Sinclair College
Building 14 – EMS Classrooms & Sim Lab
FAC 24-28X
Dayton, OH

ADDENDUM 01

Date of Addendum: January 31, 2025

This addendum consists of five (5) pages plus attachments.

LOWER LEVEL LIGHTING FLOOR PLAN - NEW WORK

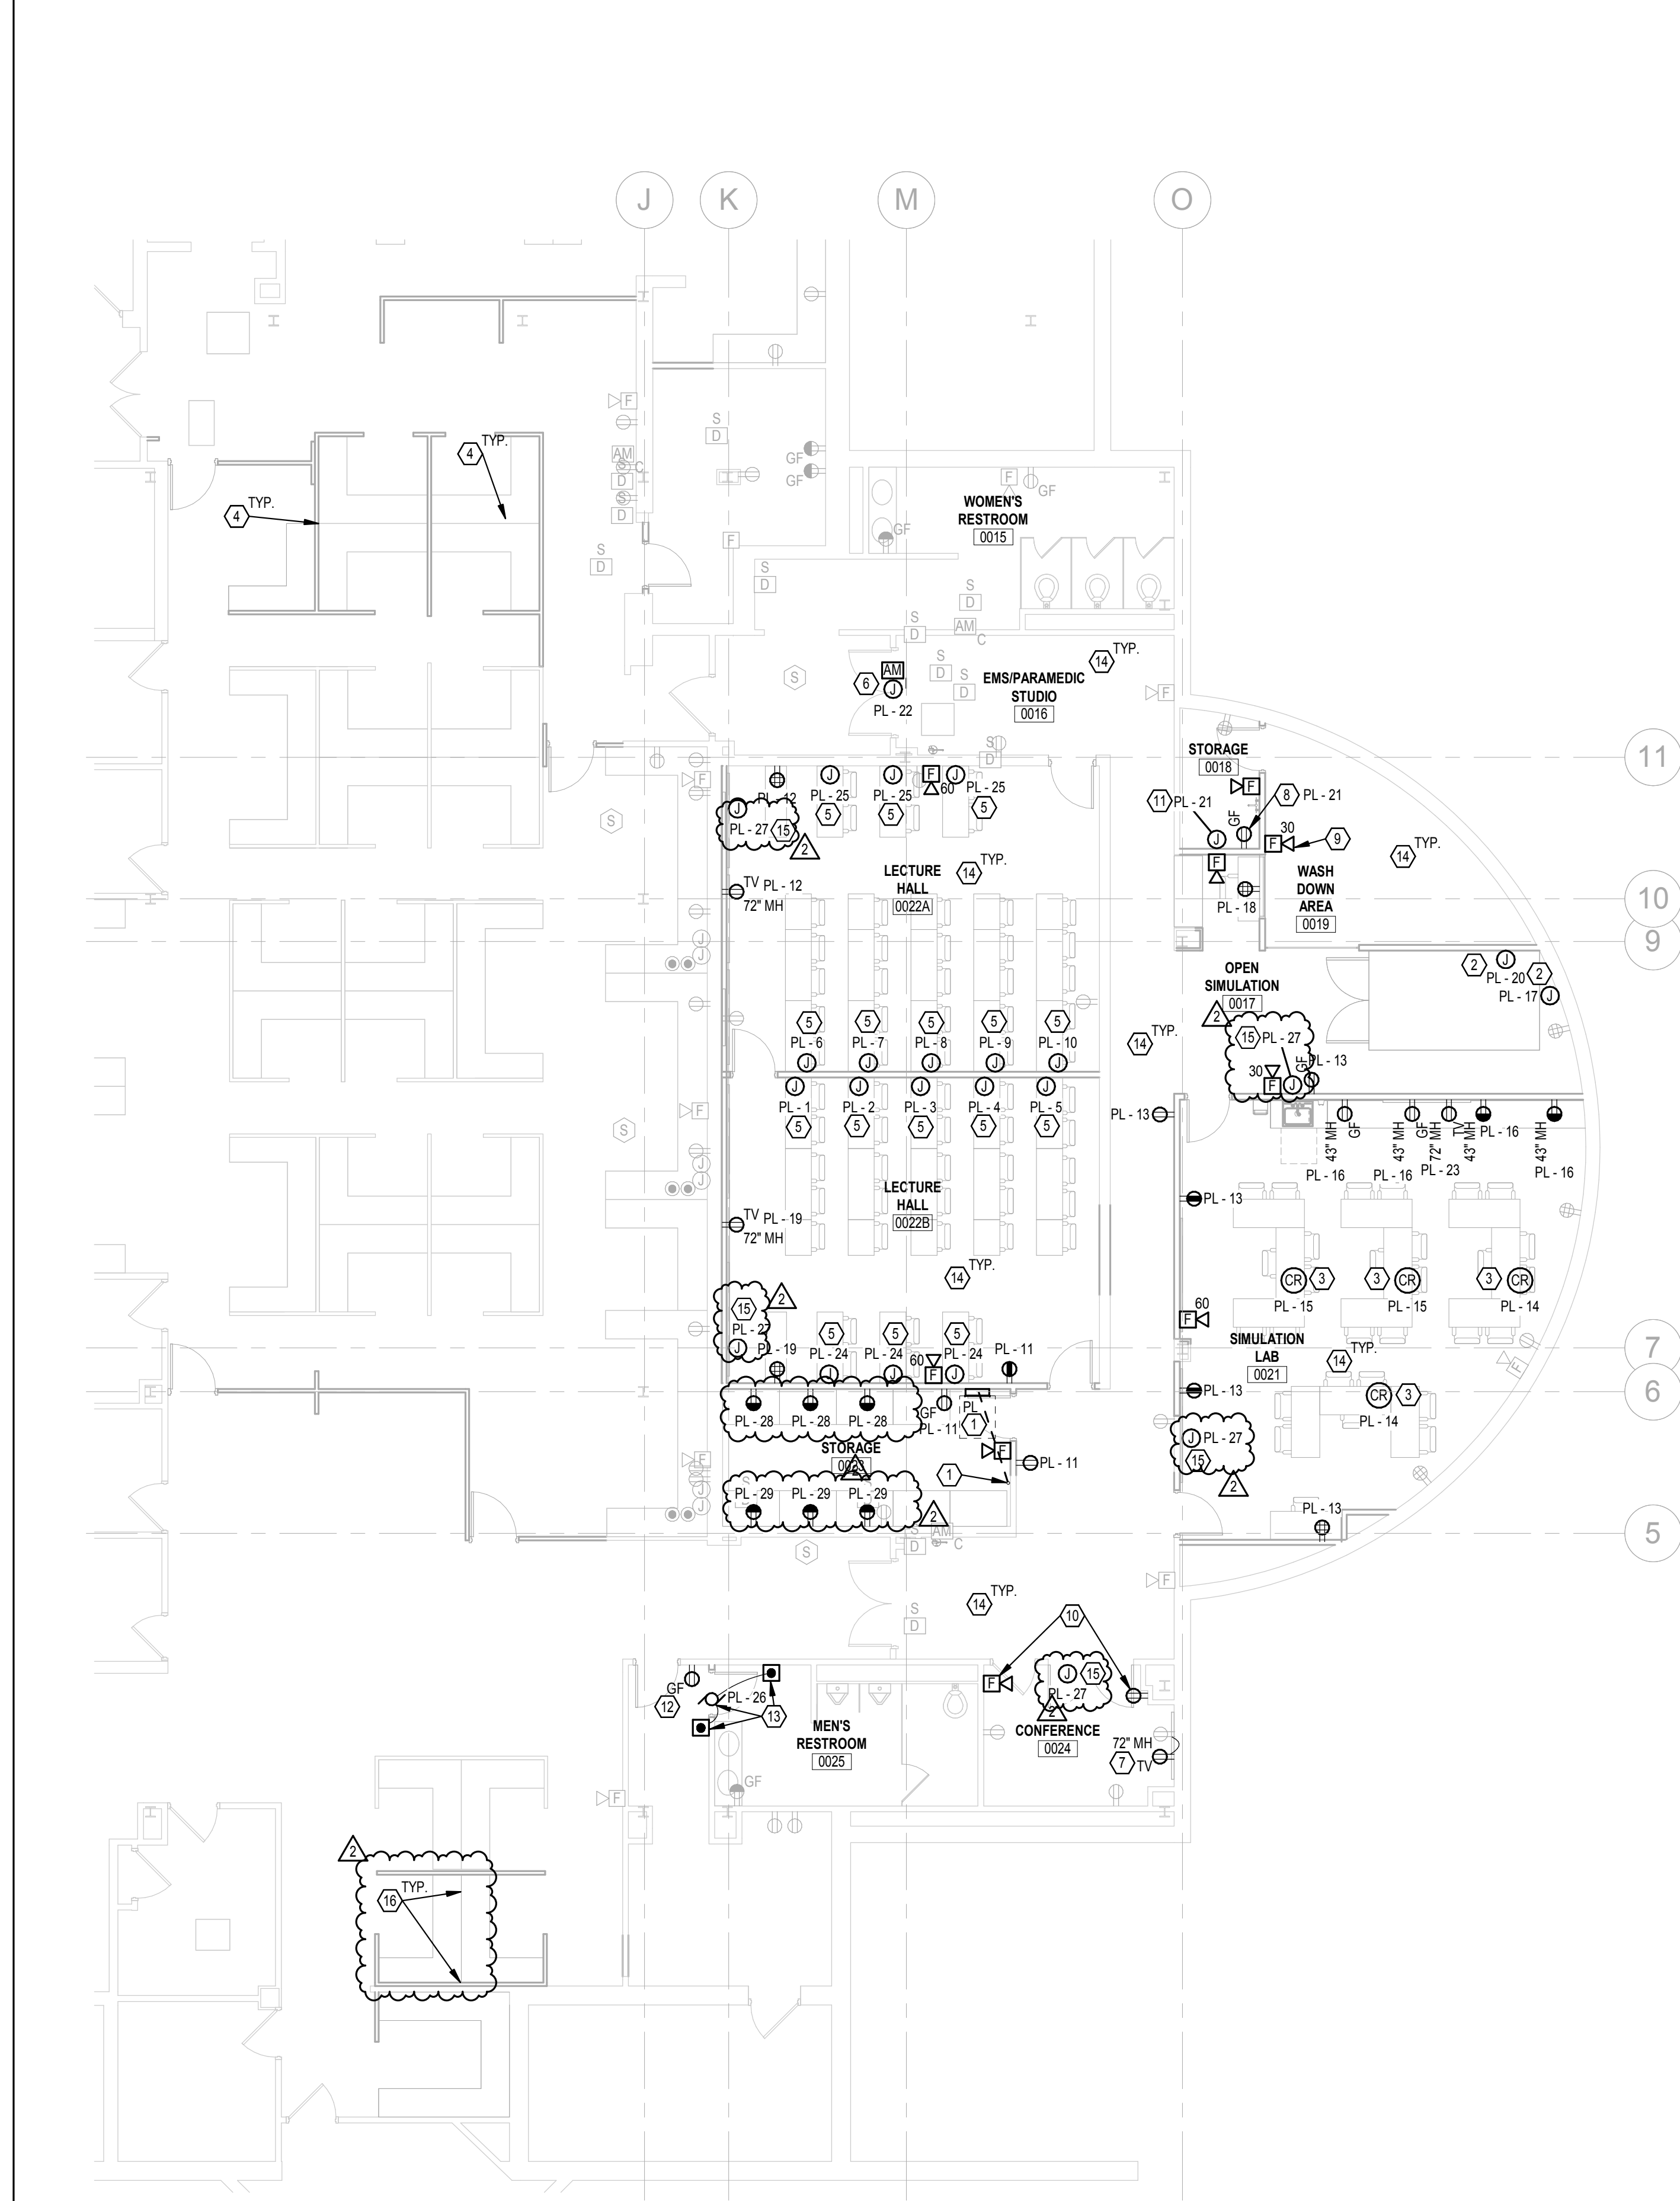
- a. Add (3) 20A circuits to PL.
7. Sheet E003 SCHEDULES
 - a. Change description of A1 to 6".
 - b. Add mark to B1 equal manufacturers.
8. Sheet E100 LOWER LEVEL LIGHTING FLOOR PLAN – NEW WORK

- a. Revise General Note M.
 - b. Add (4) B1 fixtures to 0017.
9. Sheet E200 LOWER LEVEL POWER & SYSTEMS FLOOR PLAN – NEW WORK
 - a. Add Plan Note 15, along with (5) J-boxes and (1) circuit for clock power.

- L. WHERE REMOVAL OF ELECTRICAL DEVICES/BOXES OCCURS, PATCH AS REQUIRED AND REFER TO GENERAL NOTE F ON SHEET E001 FOR MORE INFORMATION.
- M. E.C. SHALL MAINTAIN ALL LIGHTING CONTROL EQUIPMENT/DEVICES ABOVE AREA OF WORK THROUGHOUT ALL DEMO AND NEW WORK. EQUIPMENT AND DEVICES ARE LOCATED ABOVE CEILING.

**LOWER LEVEL
 POWER & SYSTEMS
 FLOOR PLAN - NEW
 WORK**

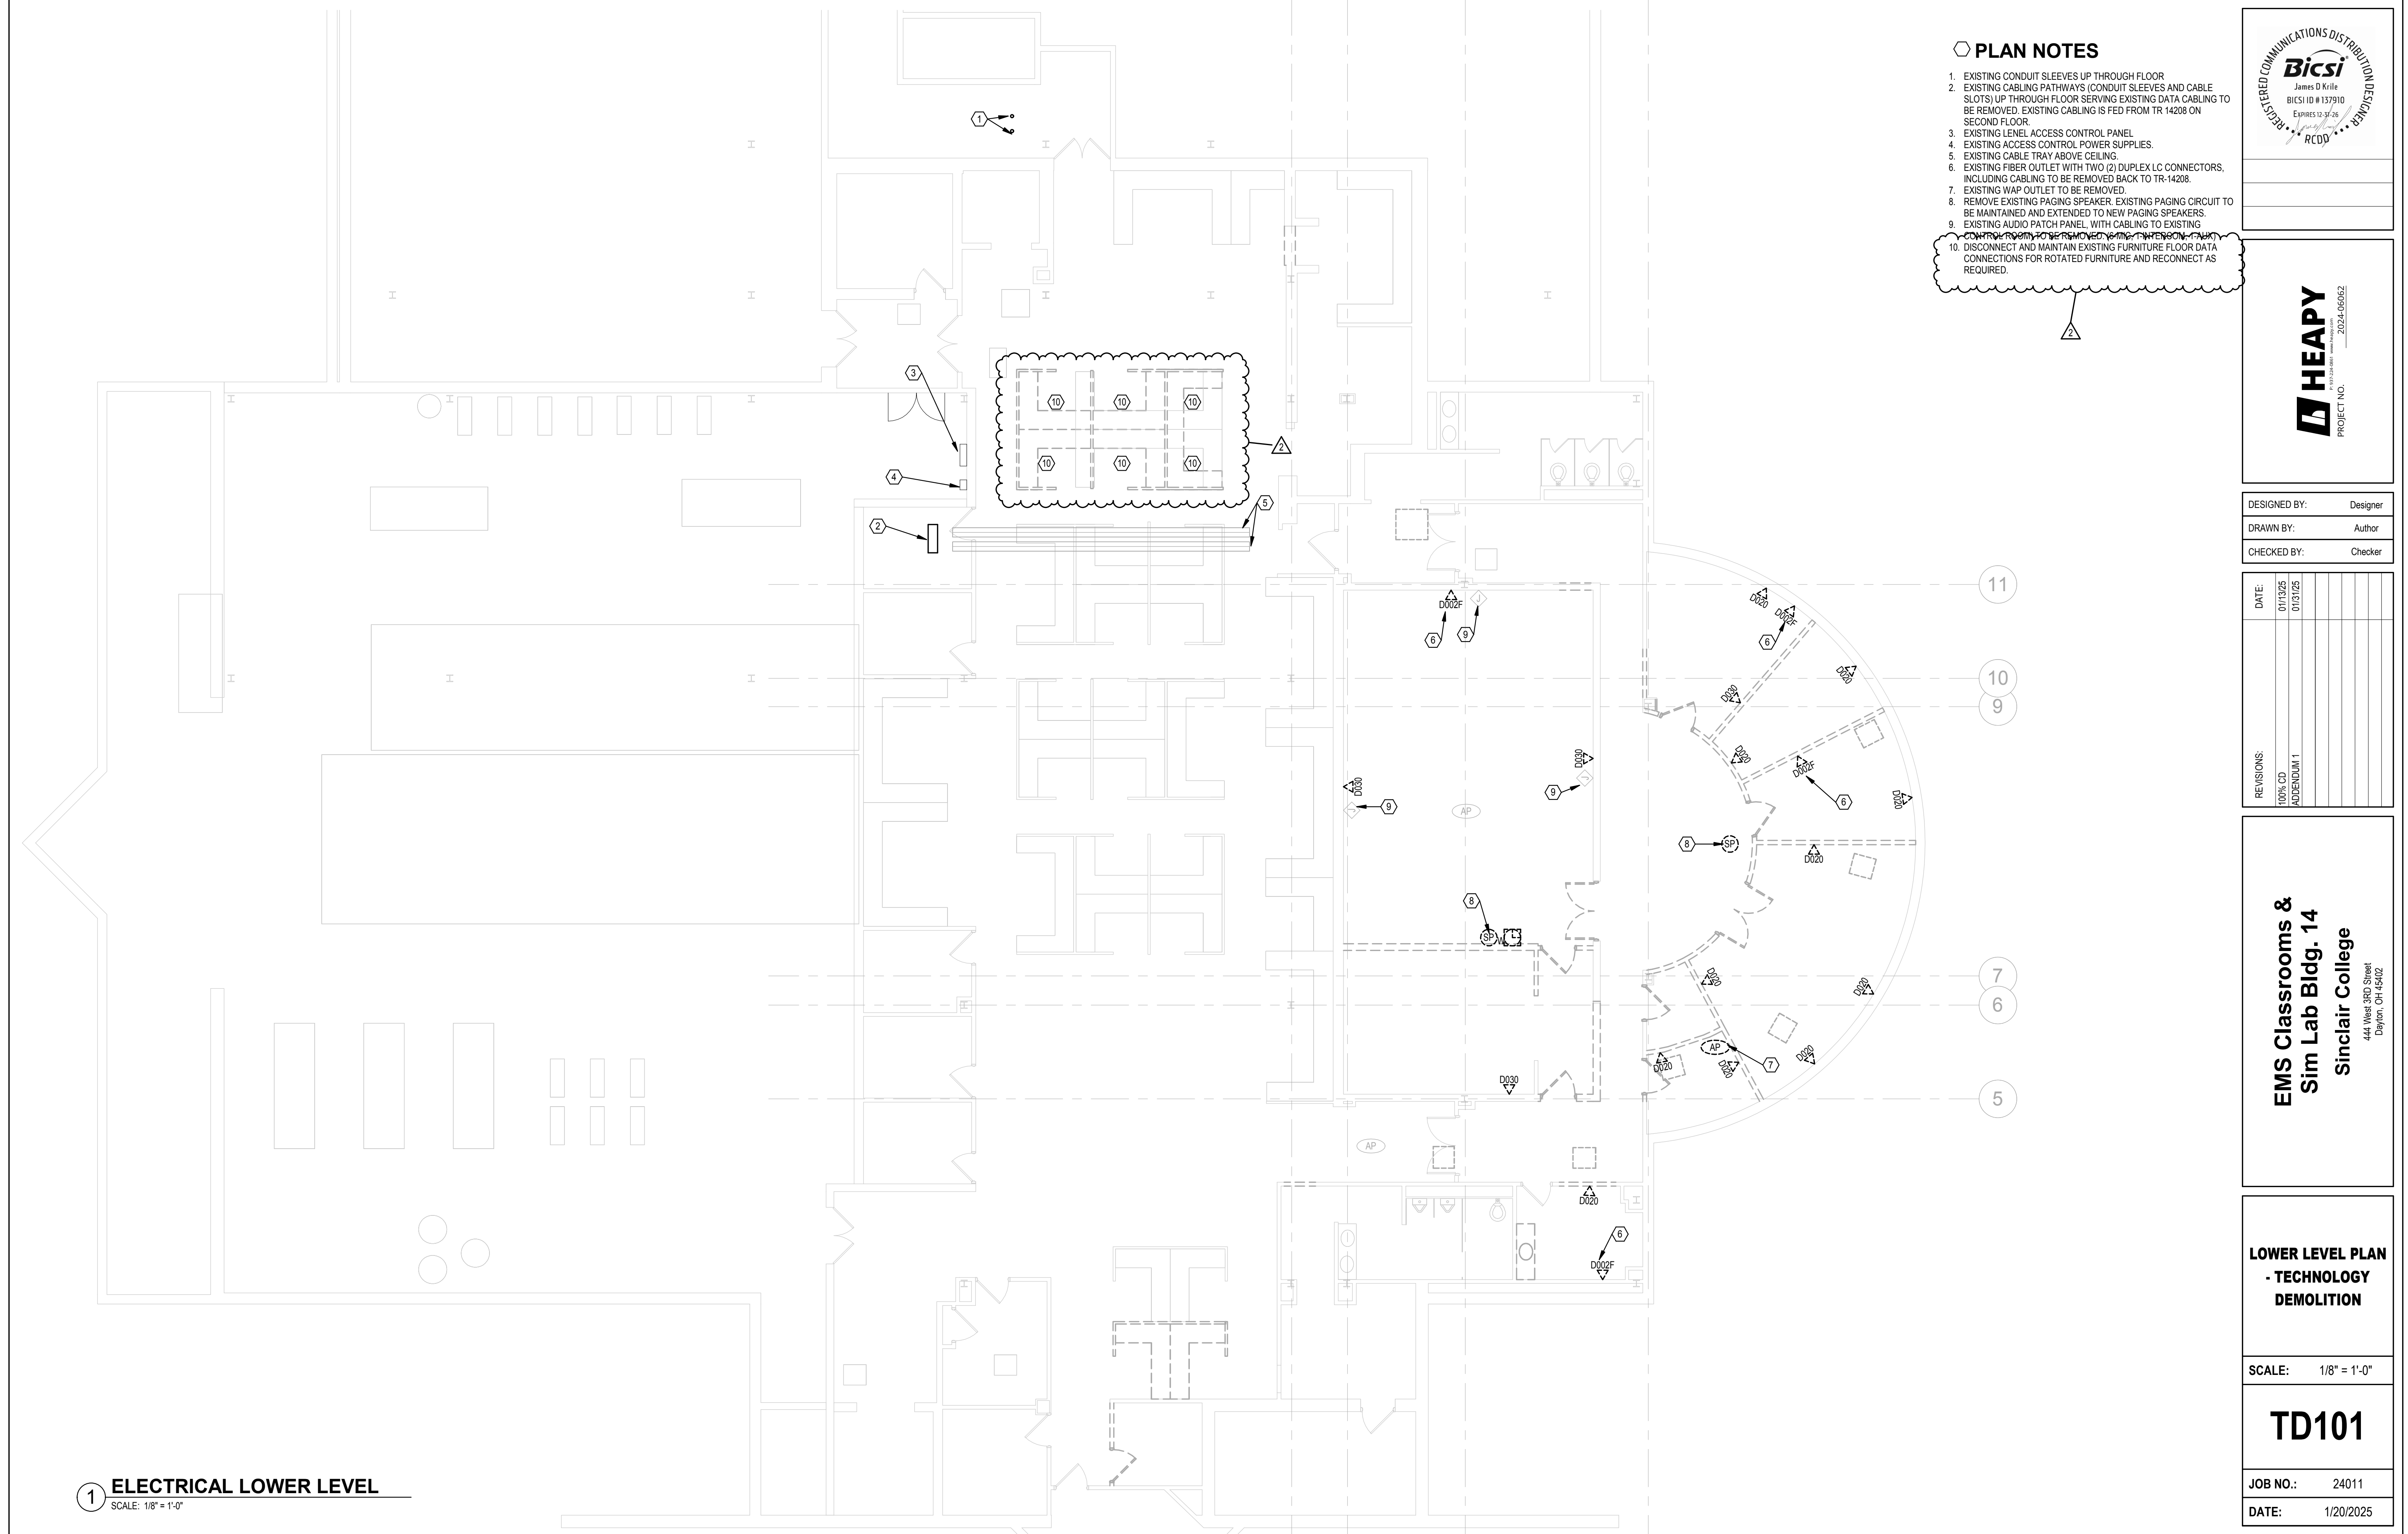
- b. Add (6) receptacles to 0023 with (2) circuits.
 - c. Add Plan Note 16 along with instance on plan for revised furniture under Alternate 2.
10. Sheet ED100 LOWER LEVEL FLOOR PLAN - DEMOLITION

- 15. PROVIDE 20A, 120V-1PH POWER CONNECTION FOR CLOCK WITH 2-#12, 1-#12 GRD IN 0.75\"/>
- 16. IF ALTERNATE 2 IS ACCEPTED, MAINTAIN EXISTING FURNITURE FLOOR/WALL POWER CONNECTIONS FOR ROTATED FURNITURE AND RECONNECT AS REQUIRED. EXTEND WIRING/WHIPS TO NEW CONNECTION LOCATIONS. MATCHING EXISTING SIZING, RATINGS AND CHARACTERISTICS. COORDINATE FINAL LOCATIONS WITH ARCHITECT AND EXISTING CONDITIONS PRIOR TO ROUGH-IN AND PROVIDE ACCORDINGLY. IF ALTERNATE 2 IS NOT ACCEPTED, NO WORK SHALL BE DONE IN THIS AREA.

TECHNOLOGY LEGEND, GENERAL NOTES & INDEX

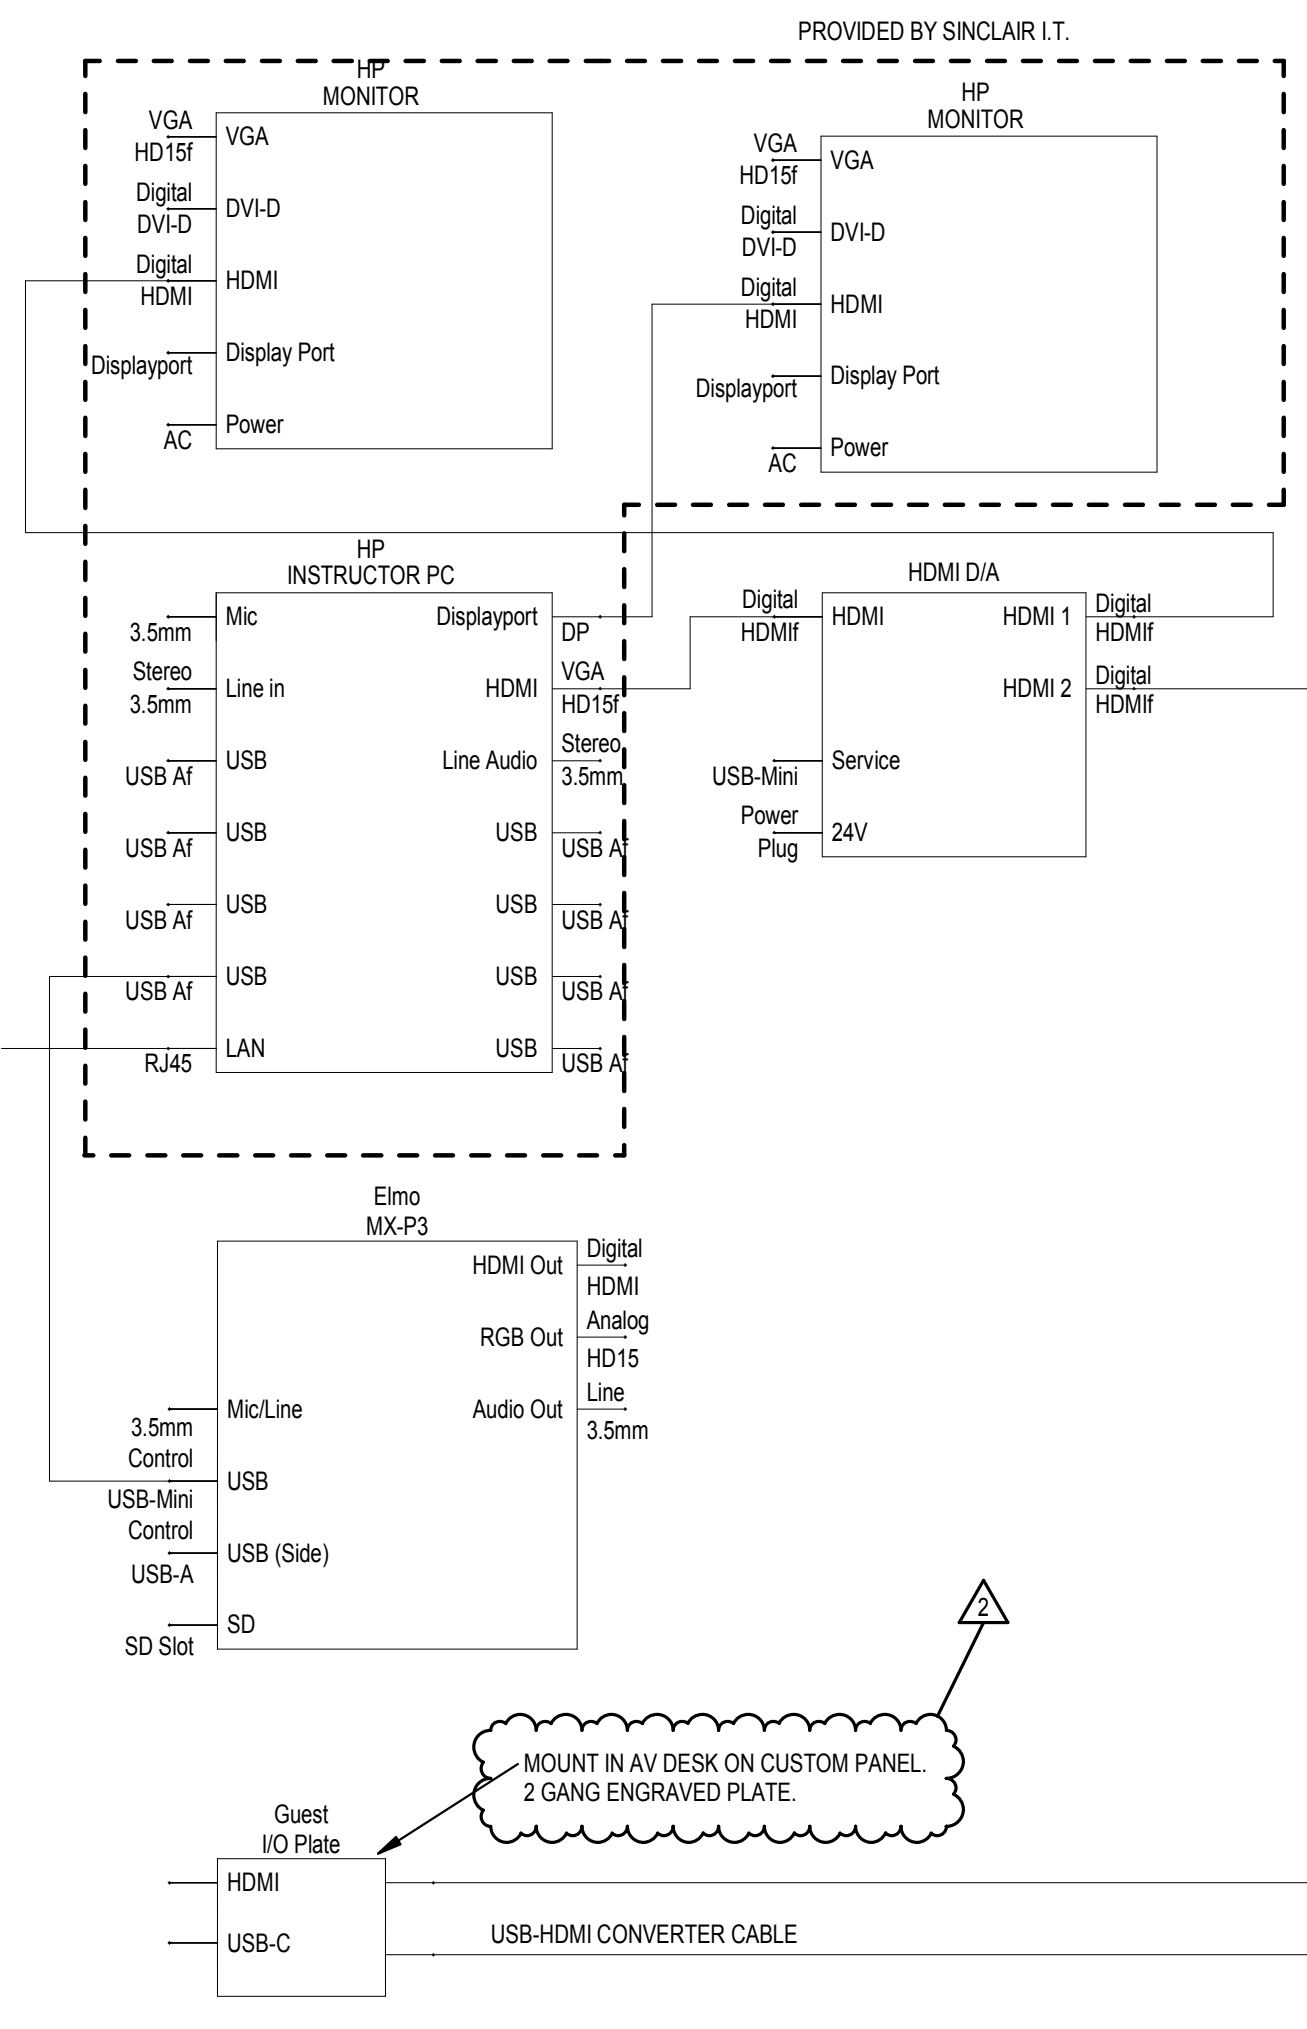
- a. Add Plan Notes 9, 10 & 11, along with instances on plan.
11. Sheet T001 TECHNOLOGY LEGEND

- a. Add Camera symbol “ellipse “CC” and description to legend
